BID
ADDENDUM NO. 3
TO
CONTRACT DOCUMENTS
AND
TECHNICAL SPECIFICATIONS
FOR
2019 BOND REFERENDUM
CAPITAL IMPROVEMENTS
AT
MAMARONECK HIGH SCHOOL
PHASE 2
NYSED #66-07-01-03-0-001-039
BID # 20/21 – MUFSD-00

Mamaroneck Union Free School District
1000 West Boston Post Road
Mamaroneck, NY 10543

LAN Job #4.1092.72.06
January 7, 2022

NORTH

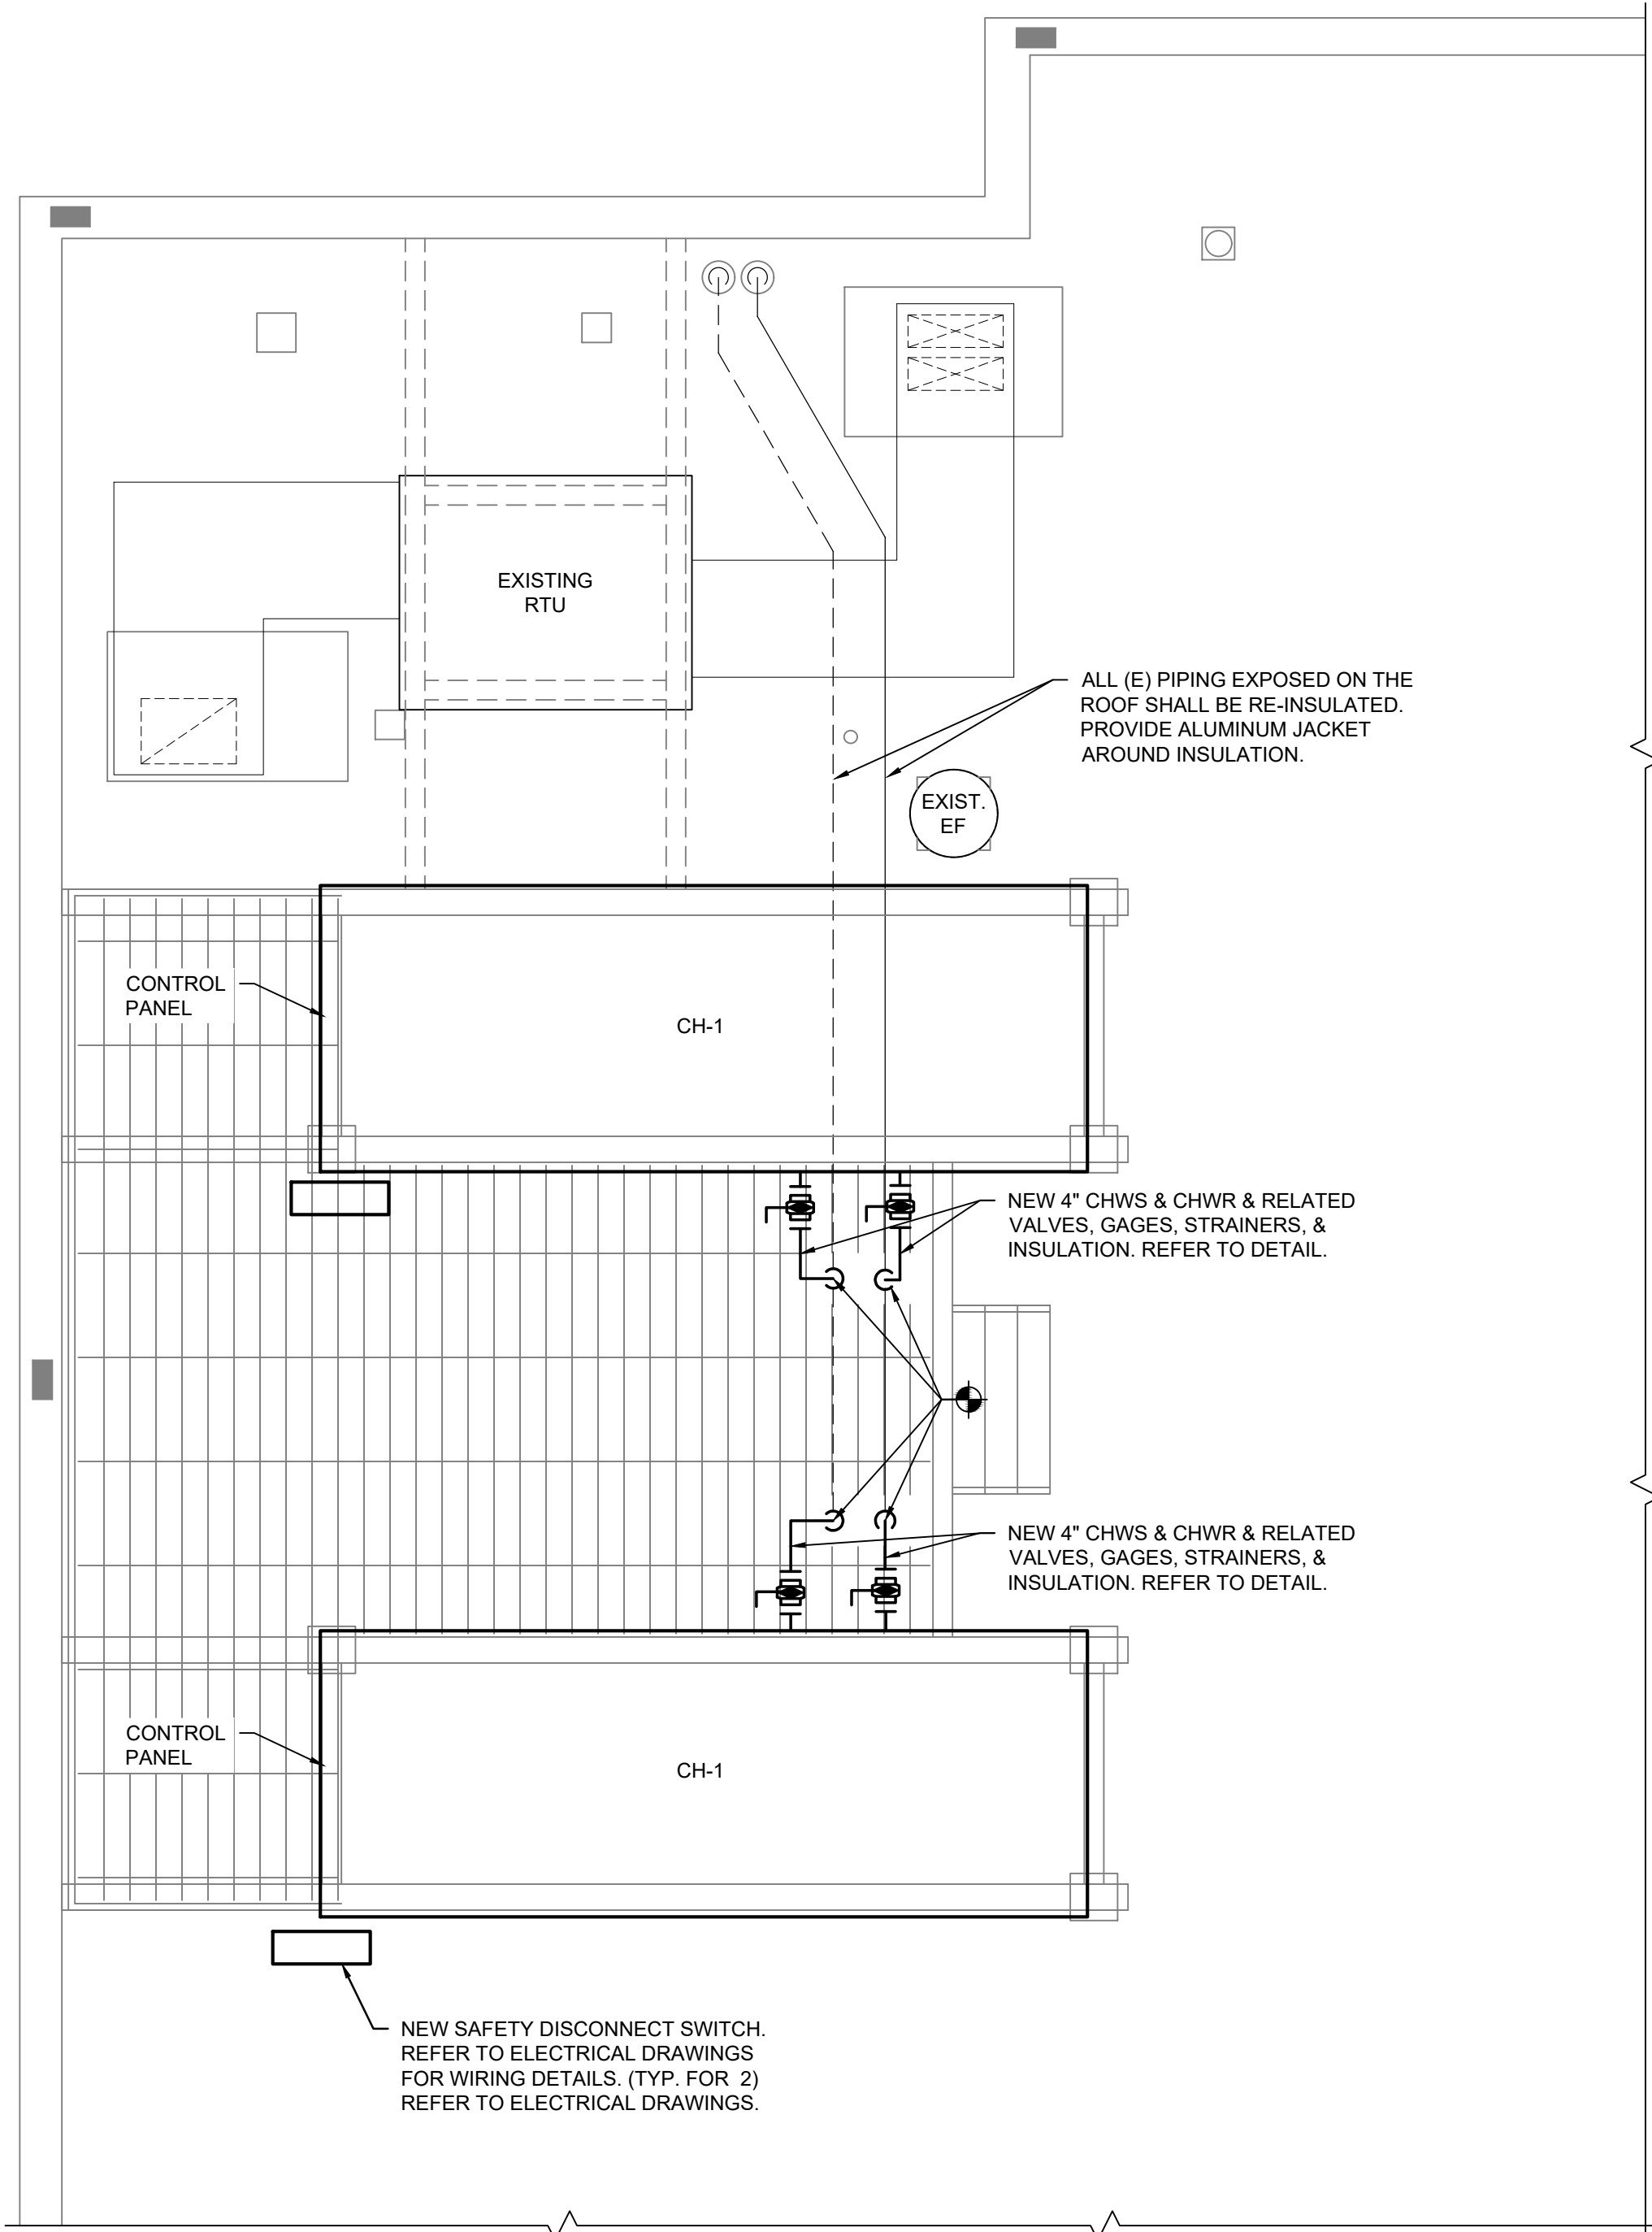
- 5 Question: M2.71 – Does the chilled water loop need to be refilled with glycol. If so what's the type and mixture percentage?
- Response: There is no glycol in the system.

- 7 Question: As discussed in the walkthrough the Existing Dunnage Scraping and Painting is to be performed by the GC. After review of the following Contract Drawings, M2.71 includes the following note, "Insert Note GC to scrape and Paint Steel Dunnage" and in addition refer to M2.91, Demo and Construction Key Notes 1, 2 & 4. Please confirm if any portion of this work including Alternate 6B-2 is to be provided by the General Contractor.

- Response: Painting of the dunnage shall be by the GC. Refer to updated drawings A0.01, A0.02, M2.71, and M2.91.
- 8 Question: Please refer to Contract Drawing M2.11, FD/SD is indicated on the plan in several locations. Please refer to M0.01 where FD/AD and FSD/AD symbols are indicated. Please clarify the desired assembly to be provided on M2.11.

DUNNAGE PAINTING NOTE:
GC TO SCRAPE, PRIME & PAINT EXISTING STEEL DUNNAGE PER THE DUNNAGE PAINTING NOTE ON DRAWINGS A0.01 & A0.02. REFER TO SPECIFICATION SECTION 099113 - EXTERIOR PAINTING FOR ADDITIONAL INFORMATION.

NYSED PROJECT # 66-07-01-03-0-001-039
PARTIAL MECHANICAL ROOF PLANS
CAPITAL IMPROVEMENTS AT
MAMARONECK HIGH SCHOOL
MAMARONECK UNION FREE SCHOOL DISTRICT
1000 BOSTON POST ROAD, MAMARONECK, NY 10543
Job No. 4.1092.72.6
File No. 10927206M290
M2.91

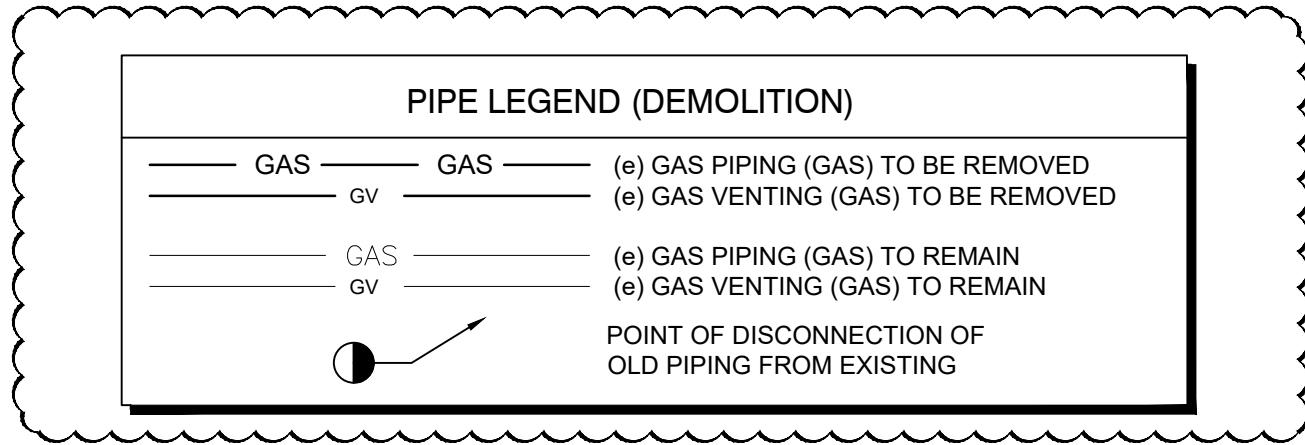
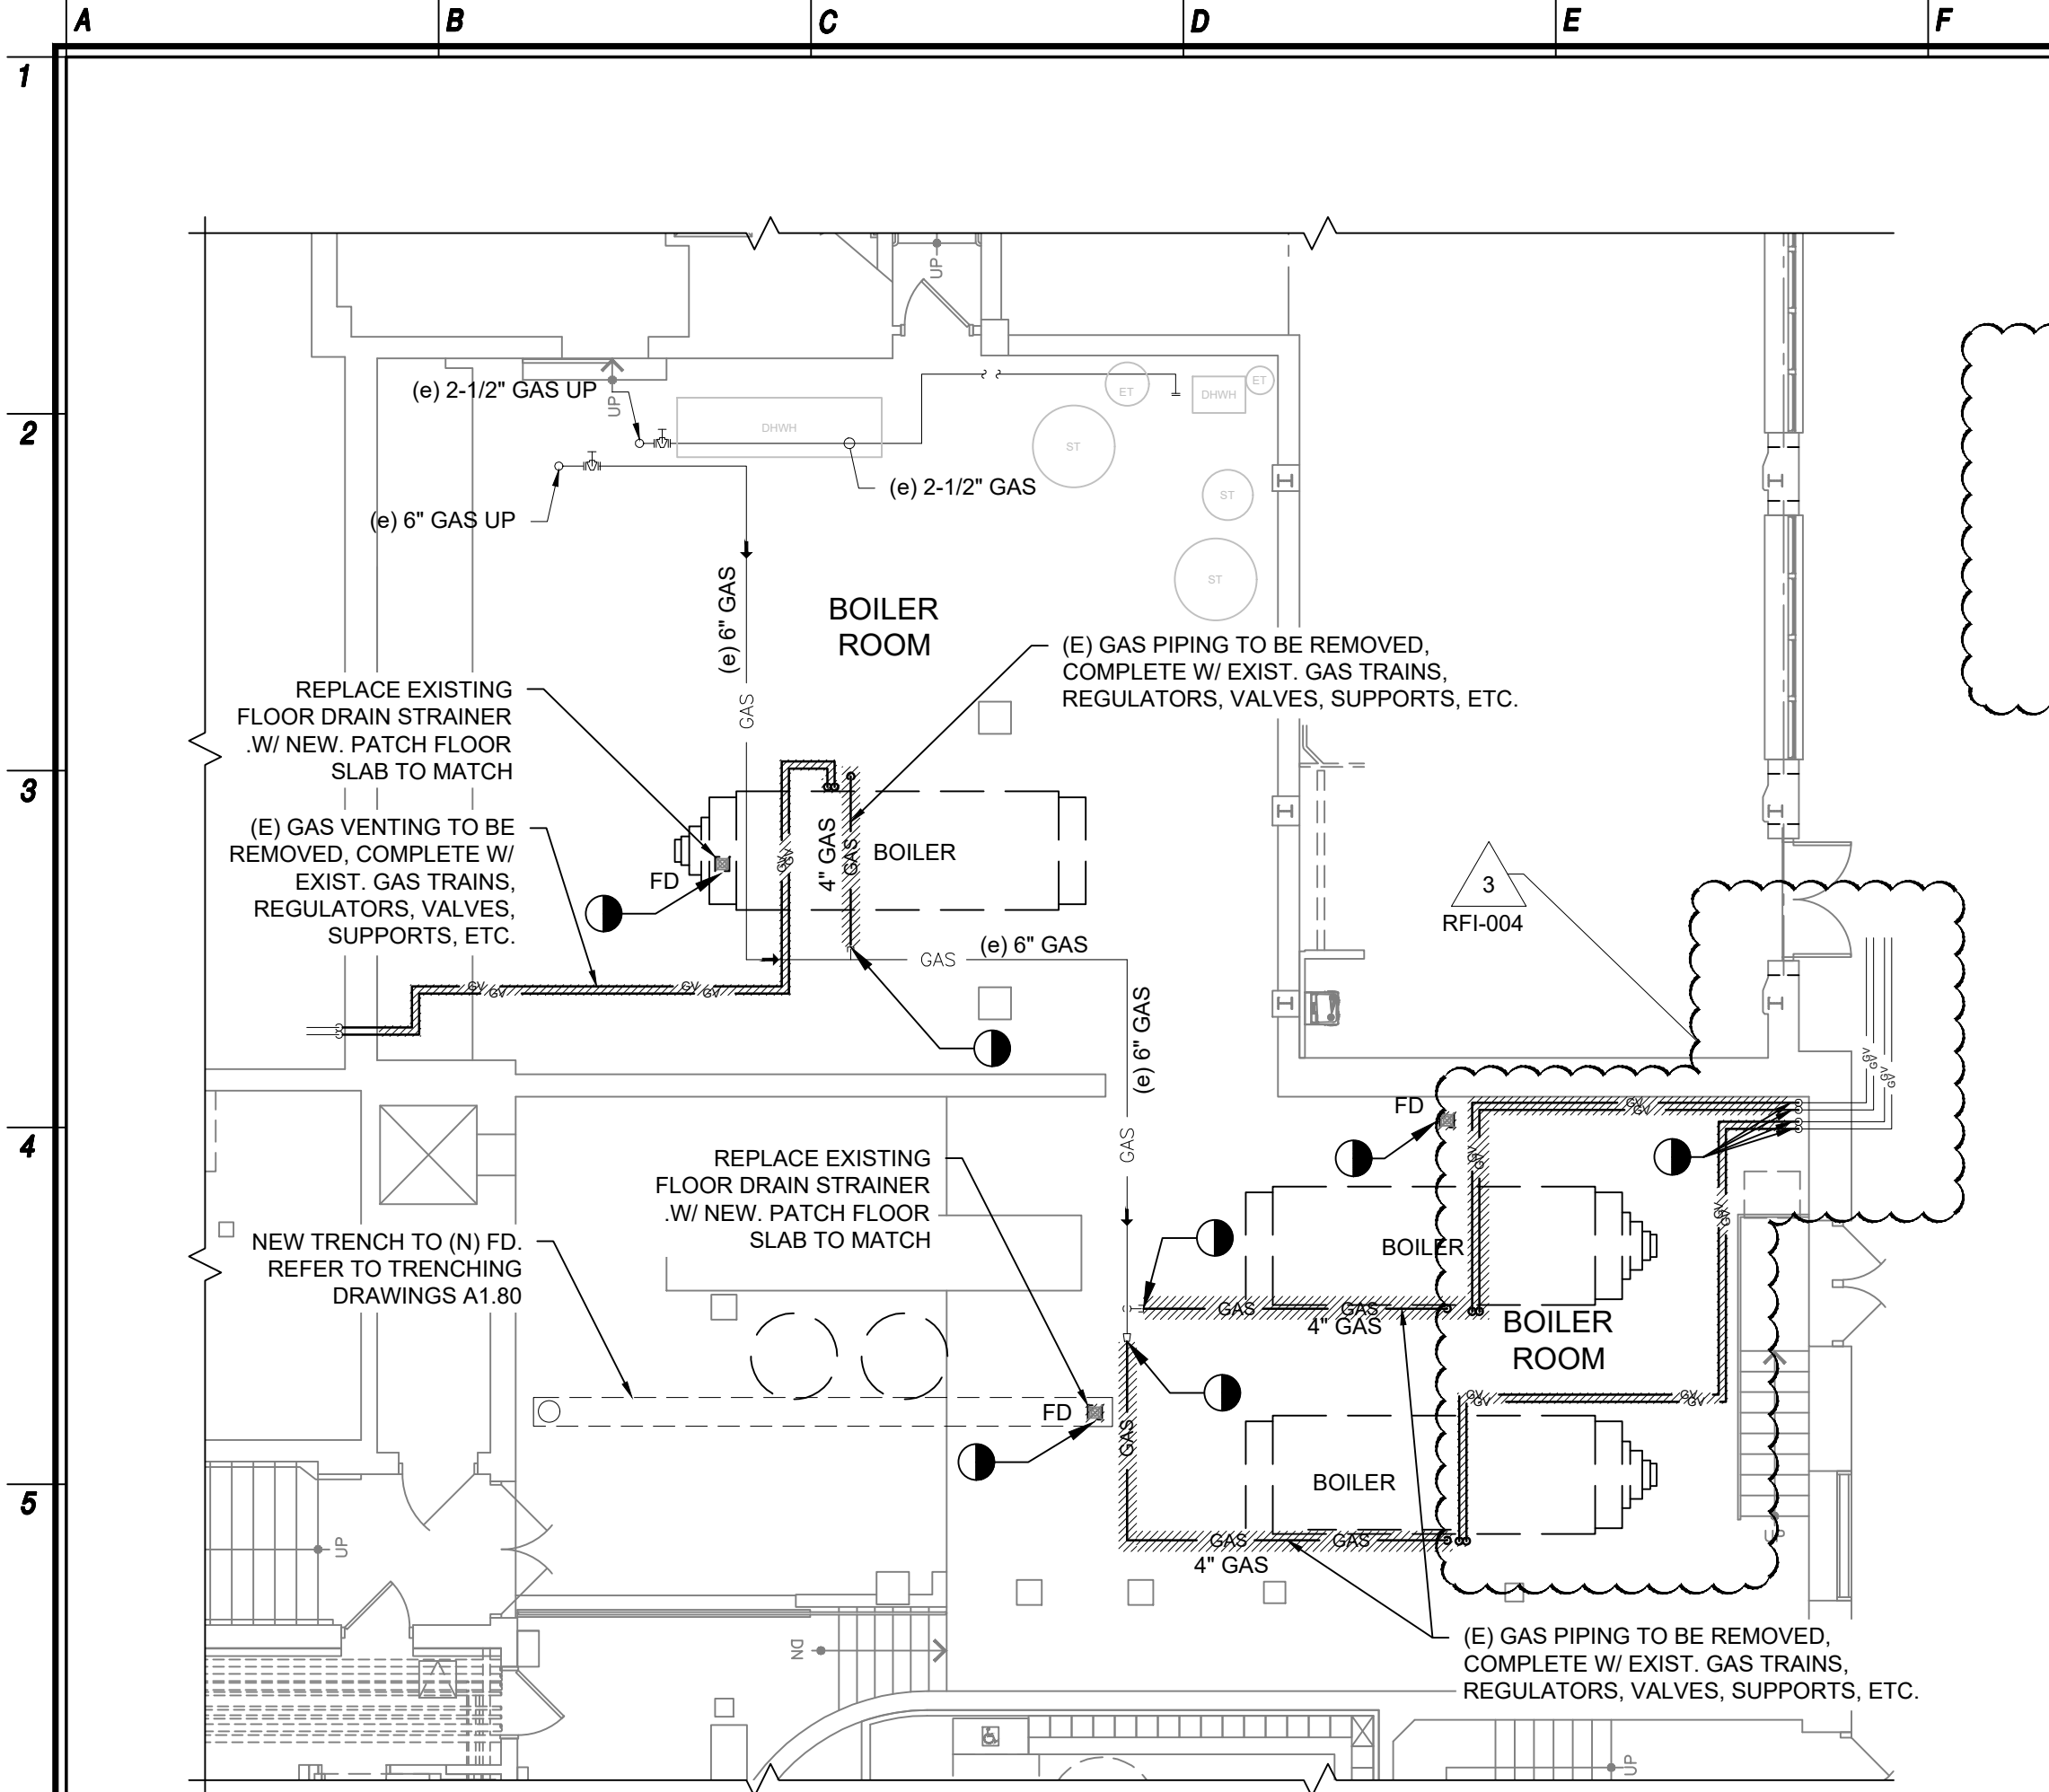
Drawing No.	Addendum Requirements
M2.91	DEMOLITION/CONSTRUCTION KEYNOTE #1 has been modified.
M6.11	Revised designation of the inline freeze protection pumps to FPP-1 & FPP-2 for MAU-1 and RTU-1, respectively.
P2.81	Drawing revised to show existing and proposed gas venting. Note added to drawing regarding existing sanitary piping.
E2.10	Drawing updated to add additional data jacks and requirements.
E2.11	Drawing updated to add circuiting for Sewage Pump Kit and to add additional data jacks and requirements.
E2.12	Drawing updated to add additional data jacks and requirements.
E2.13	Drawing updated to add circuiting for pumps P-1 & P-2.
E2.20	Drawing updated to add additional data jacks and requirements.
E2.22	Drawing updated to add circuiting for pump RCP-1.
FA2.10	Drawing updated to reflect the work requirements associated with the Fire Smoke Dampers ("FSD/AD").

ITEM #	DEMOLITION / CONSTRUCTION KEY NOTES
1	EXISTING STEEL DUNNAGE TO REMAIN. GO TO SCRAPE, PRIME & PAINT. EXISTING STEEL DUNNAGE PER DUNNAGE PAINTING NOTE ON A0.01 & A0.02. REFER TO SPECIFICATION SECTION 099113 - EXTERIOR PAINTING FOR ADDITIONAL INFORMATION.
2	EXISTING CHILLERS TO BE REPLACED. REFER TO MECHANICAL DRAWING M2.71 FOR CHILLER REPLACEMENT PROJECT FOR ADDITIONAL INFORMATION. COORDINATE SCRAPING AND PAINTING OF EXISTING STEEL DUNNAGE WITH REPLACEMENT OF EXISTING CHILLERS.
3	EXISTING ROOFTOP MECHANICAL EQUIPMENT (ROOFTOP UNITS (RTUs), ETC.) AND ASSOCIATED DUCTWORK, PIPING, SUPPORTS, CONTROLS, ELECTRICAL, ETC. TO REMAIN.
4	EXISTING ROOFTOP UNIT (RTU) TO BE REPLACED. REFER TO MECHANICAL DRAWINGS M1.20s, M2.20s AND M6.20s FOR NEW CULINARY ARTS RENOVATION PROJECT FOR ADDITIONAL INFORMATION. COORDINATE SCRAPING AND PAINTING OF EXISTING STEEL DUNNAGE WITH REPLACEMENT OF EXISTING RTU.
5	EXISTING ROOFTOP UNIT (RTU) AND ASSOCIATED DUCT, PIPING, POWER EXHAUST FAN, SUPPORTS, CONTROLS, ELECTRICAL, ETC. TO REMAIN. EXISTING EXTERIOR OUTDOOR DUCT INSULATION TO BE REPLACED WITH NEW.
